**NARRAGANSETT BAY COMMISSION
ONE SERVICE ROAD PROVIDENCE, RI 02905**

**CSO PHASE IIIA
OF-217 Consolidation Conduit
CONTRACT 308.05C**

**ADDENDUM NO. 1
August 19, 2021**

NBC CONTRACT NO 308.05C
CIVIL

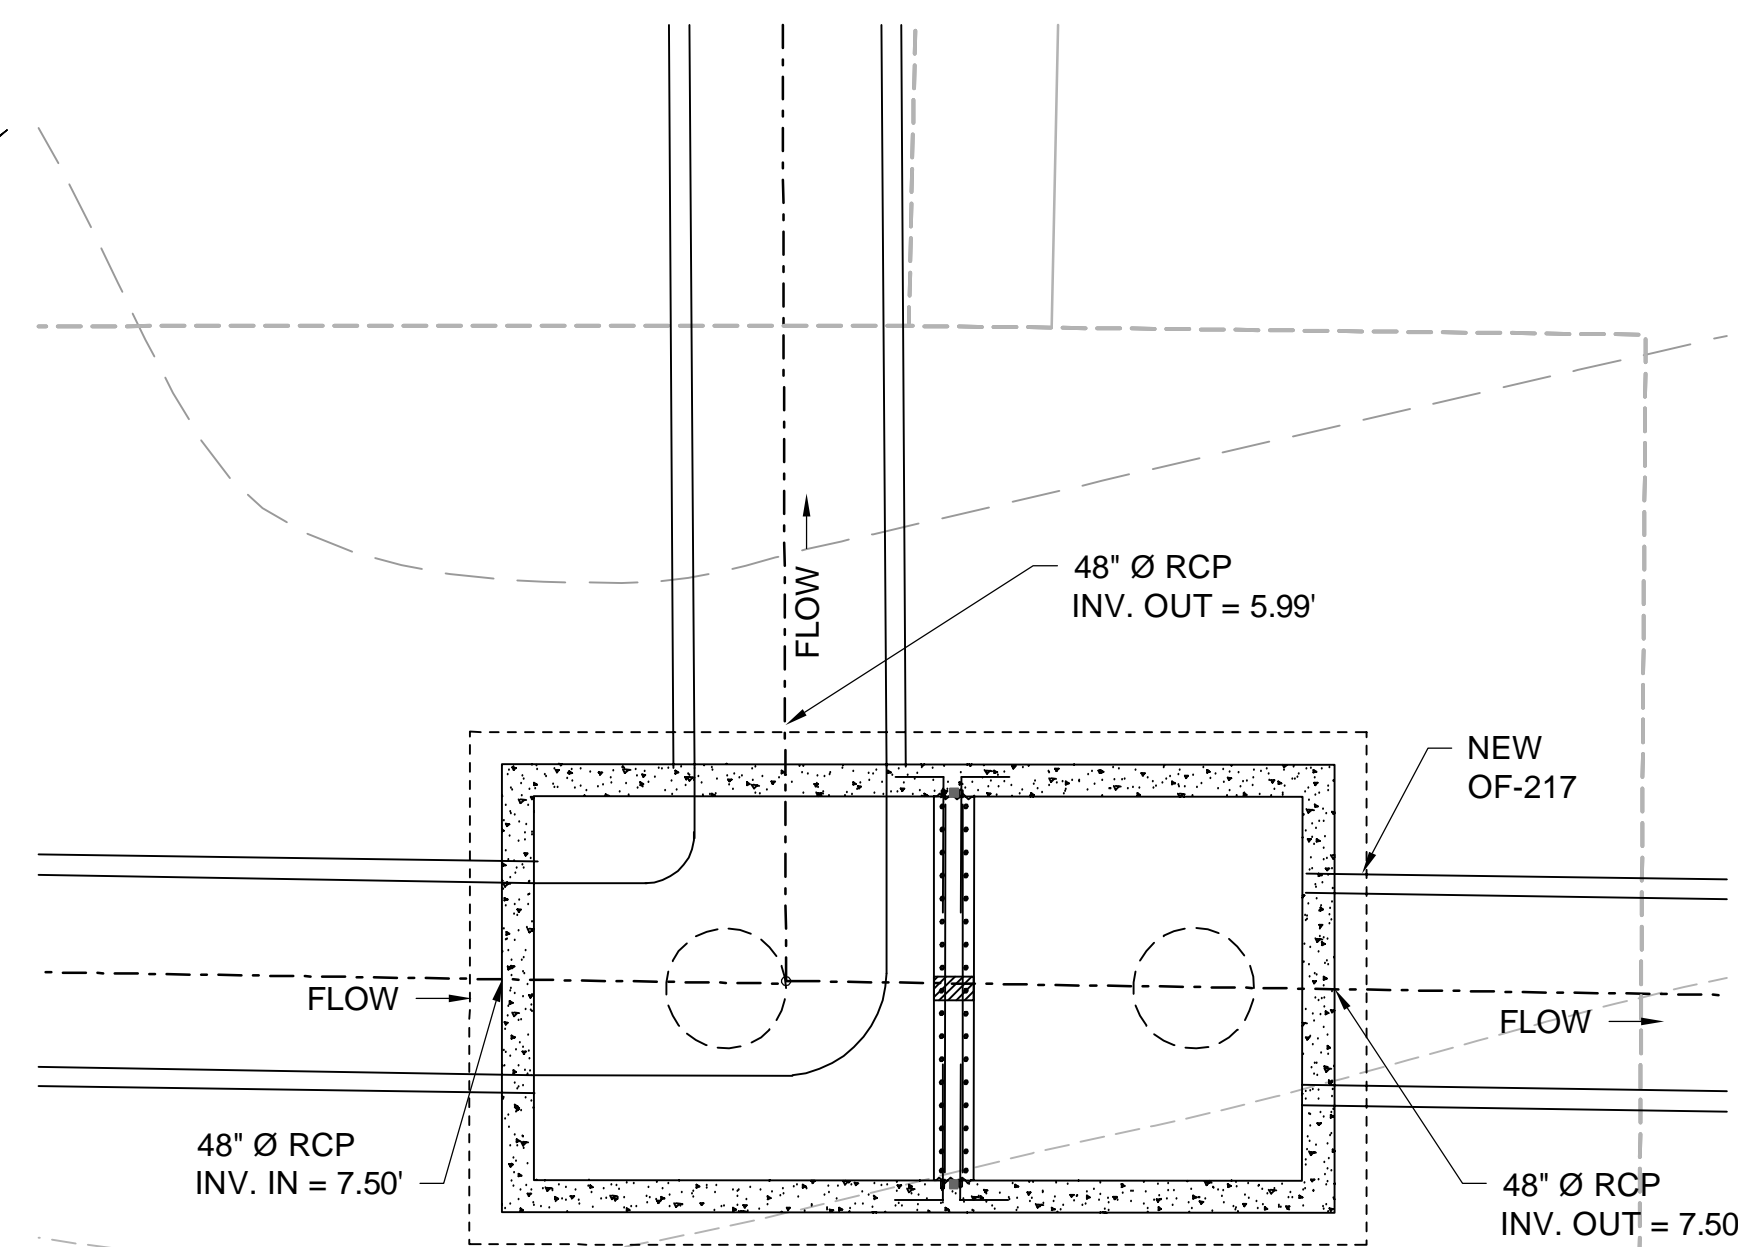
Item 1-9: Drawing C-8 shall be **DELETED** and **REPLACED** with Drawing C-8 attached hereto (see Addendum No. 1, Attachment 6).

4. Sheet c-8 profile shows two 6" water lines at stations 2+80 and 3.12 but they are not shown on the plan. Are they in fact there and if so, do will they require cutting and capping?

Response: Water mains are known to be abandoned. Please see Addendum 1, Item 1-9.
